# **Southgate Project**

## **Comments on the Draft EIS and Responses**

### **Southgate Project Response to Comments Side-by-Side Table**

Figure I-3: Trends in Per Capita Consumption by 14 Sectors (Btu)

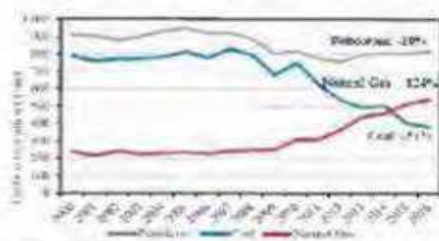
**Purpose and Need:** The DEIS was not clear concerning a full description of the purpose and need for the action(s). In the Section 1.1 Purpose and Need, the document stated a description of the proposal and how the Commission bases its decisions. However, the need for this project remained uncertain. The purpose and need of the proposed project stated in the DEIS is: "...to meet the specific requests for natural gas transportation service of its anchor shipper, Dominion Energy (formerly PSNC Energy), a local natural gas distribution company." Additionally, the Commission directed the readers to its "Certificate Policy Statement"<sup>1</sup> to try to clarify how the Commission evaluates the need for the project, and as the Commission states in the DEIS: "...whether there is a need for a proposed project and whether the proposed project would serve the public interest. The Commission decision, in its Order, would review the need for the Project."

**Recommendations:** The EPA recognizes that this section of the DEIS needs to be further developed as the Commission receives agency and public input. While finalizing this discussion, the EPA has provided some general information regarding NC's demand/consumption regarding three energy sectors (See chart below). It is noted that in NC the natural gas sector has increased by more than 100%, but we also noted that the available volume of gas as of today is already exceeding NC's present consumption<sup>2</sup>. We understand that one of the many issues FERC considers for its decision is market demand and supply. We recommend that the FEIS include a well-defined purpose and need that would address the underlining need for this project that balances the benefits and impacts from the proposal.

See response GEN-2 in appendix I.2.

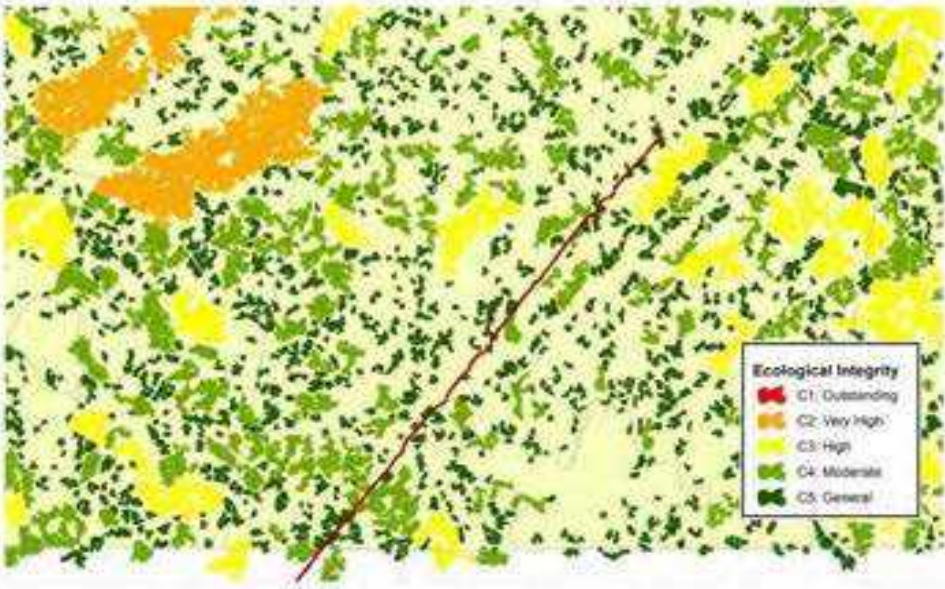
CO-30	Virginia Forest Conservation Group
CO-30a	<p data-bbox="289 235 1228 305"><u>Figure 2. Ecological Cores and Habitat Fragments from the VaNLA 2017 with the proposed MVP Southgate project route.</u></p>  <p data-bbox="289 941 1228 1347">This review employs the same methodology used to assess forest fragmentation impacts of the main route of the MVP (i.e. the 303-mile span from northwestern West Virginia to southern Virginia). This method addresses both direct and indirect impacts by calculating forest lost, even if only temporary, as well as loss of integrity of core forest due to fragmentation that reduces interior area, increases perimeter, and/or decreases the depth of core forest. For background information and methodology specifics, see this document on the Federal Energy Regulatory Commission (FERC) docket: "Commonwealth of Virginia Department of Conservation and Recreation comments on MVP FEIS and Forest Fragmentation Impacts and Mitigation Recommendations of Virginia State Agency Staff under CP16-10" (<a href="http://elibrary.FERC.gov/idmws/file_list.asp?accession_num=20170721-5183">http://elibrary.FERC.gov/idmws/file_list.asp?accession_num=20170721-5183</a>).</p>

Section 4.5.4.3 of the EIS discusses impacts related to forest fragmentation. This section has been updated with additional analysis on forest fragmentation. In addition, Mountain Valley has committed to minimizing impacts on forest land and continues to coordinate with VADCR on tree clearing mitigation prior to clearing trees.
